COMMUNITY DEVELOPMENT DEPARTMENT
501 Delta Avenue ♦ Marysville, WA 98270 ♦ (360) 363-8000

Re: M-51 Industrial – *Technical Review 2*
PA 23014

After reviewing the revised application materials for the above referenced proposal, the following comments have been prepared:

MIC NORTH - EXISTING

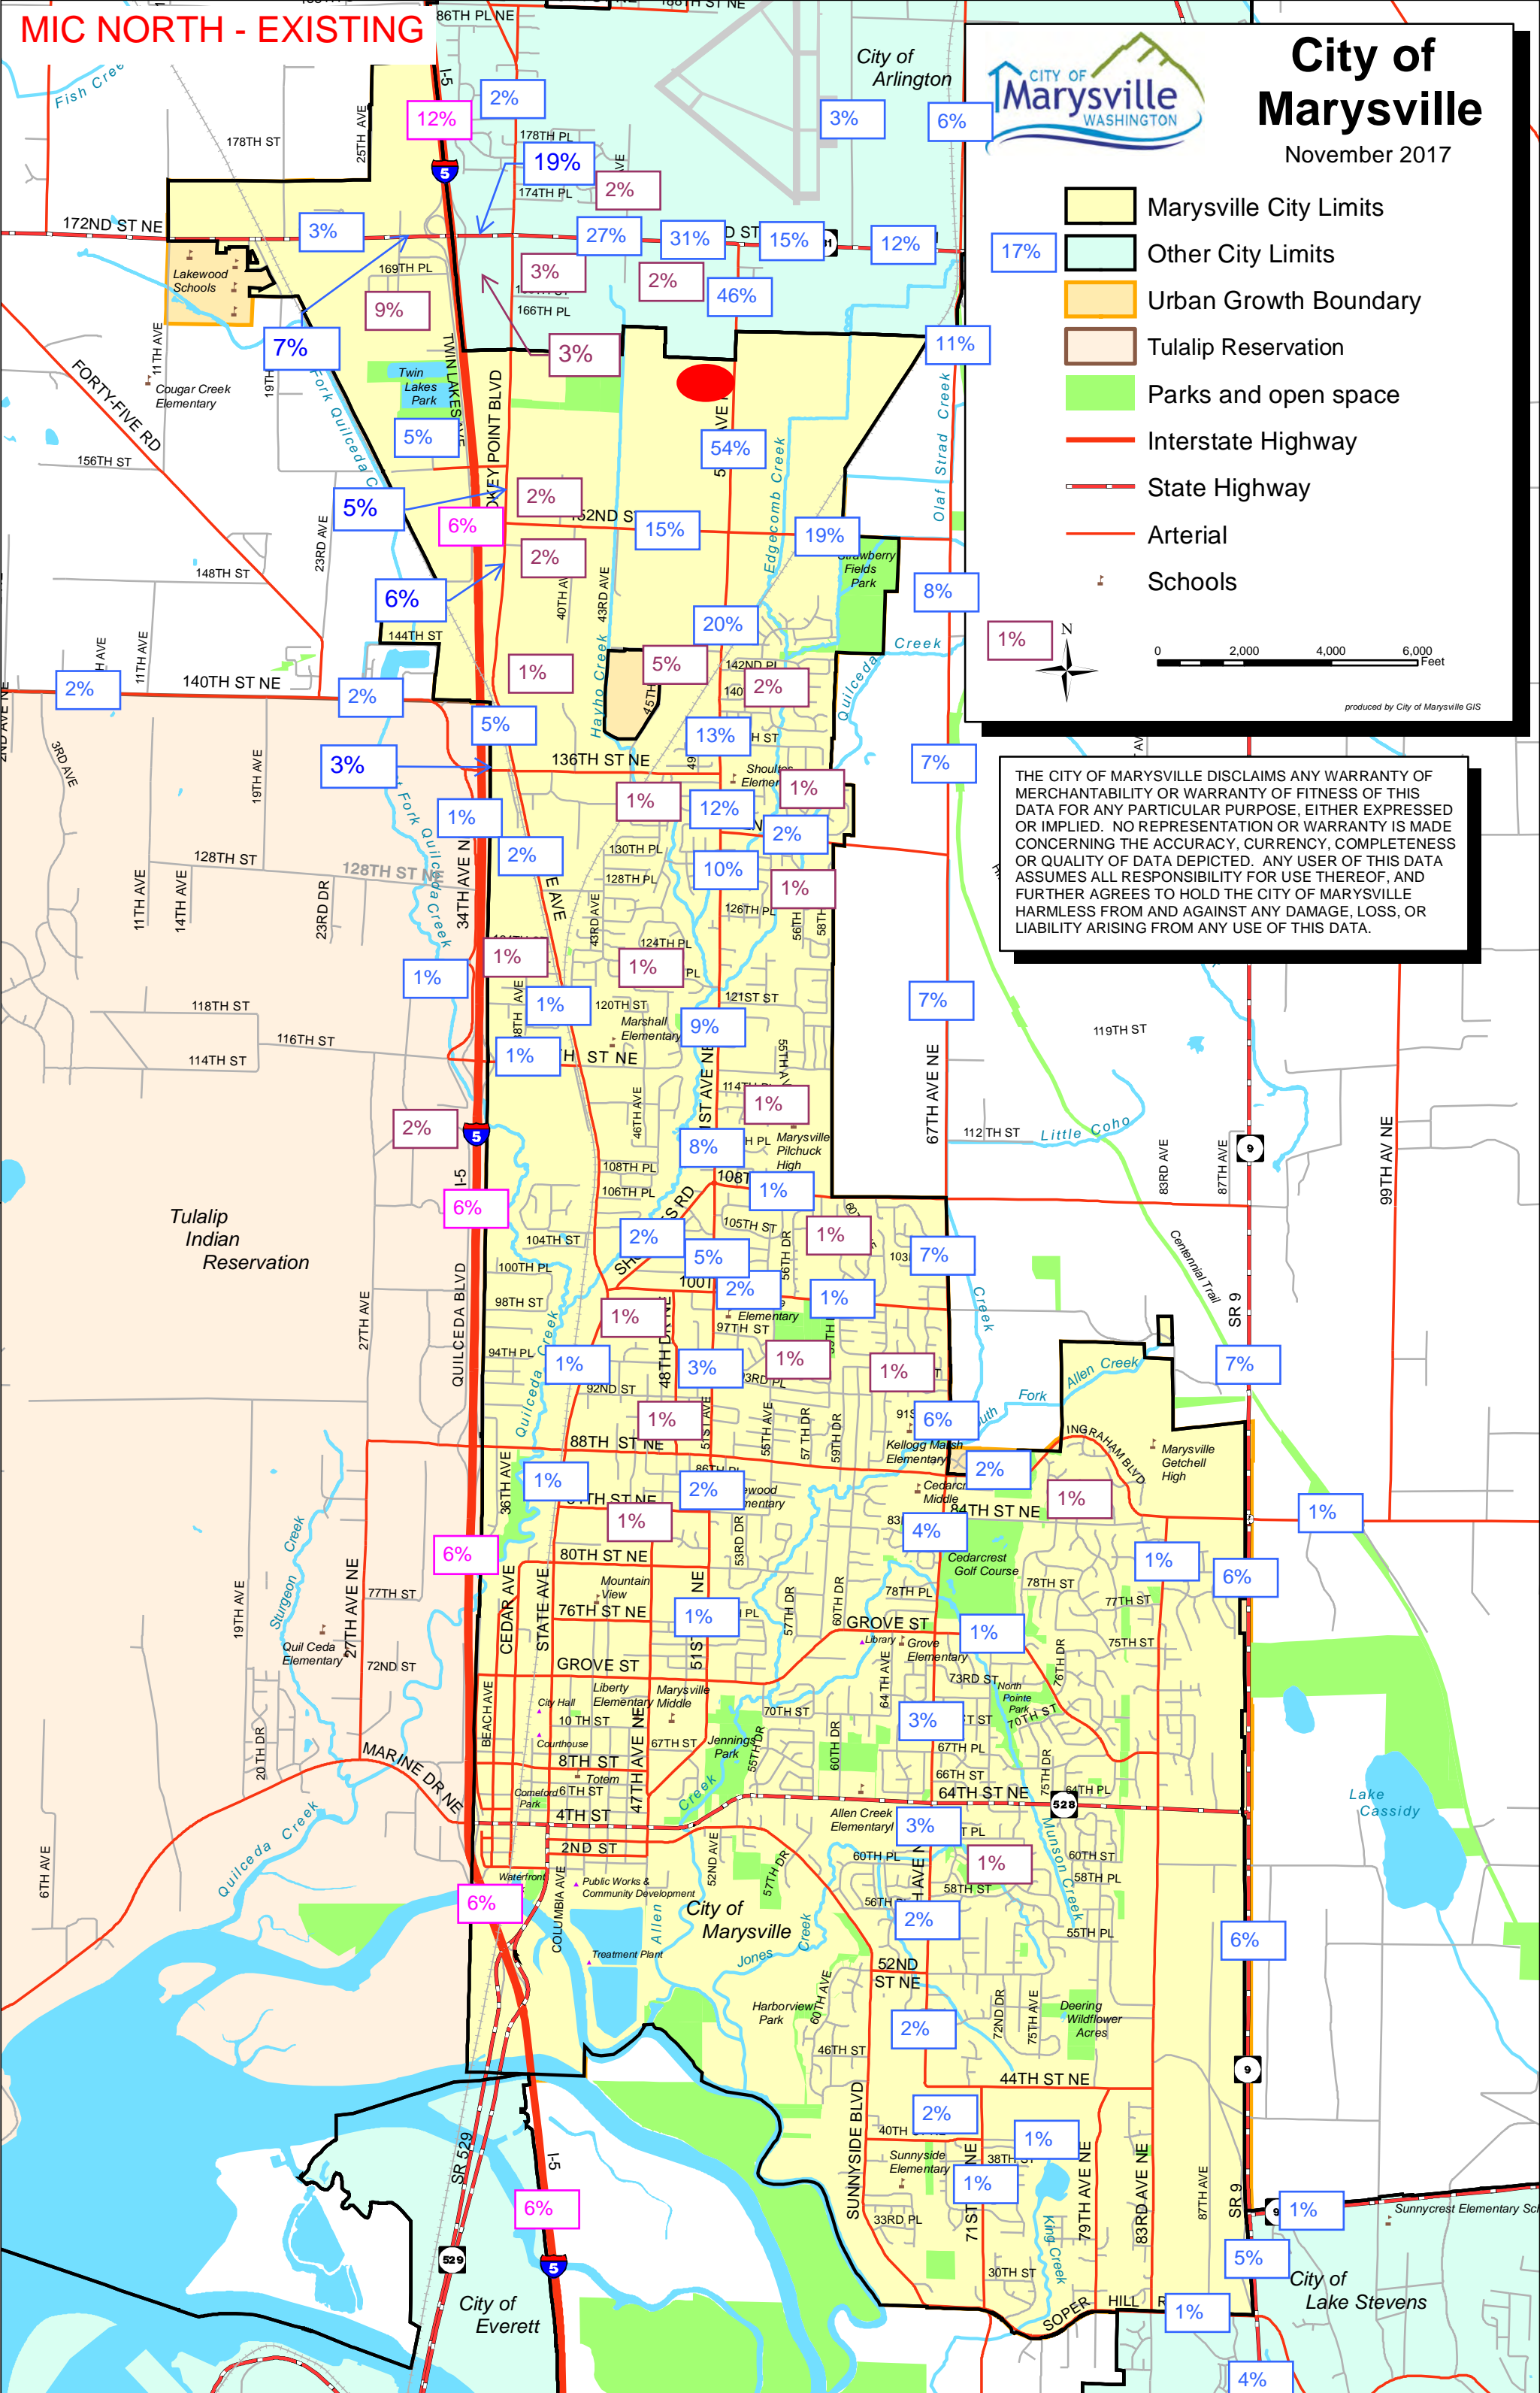
- b. The estimated trip generation is approved and resulting impact fees for City and County impacts appear correct.
 - c. Year of opening (2026) trip distribution patterns should match the City’s “MIC North-Existing” trip distribution figures previously provided along with TIA Guidelines during the previous review. The TIA’s distribution sends a substantially greater percentage of traffic north of the site. This modification does not appear likely to alter the TIA conclusions but should be updated for consistency with other development proposals and City planning documents.
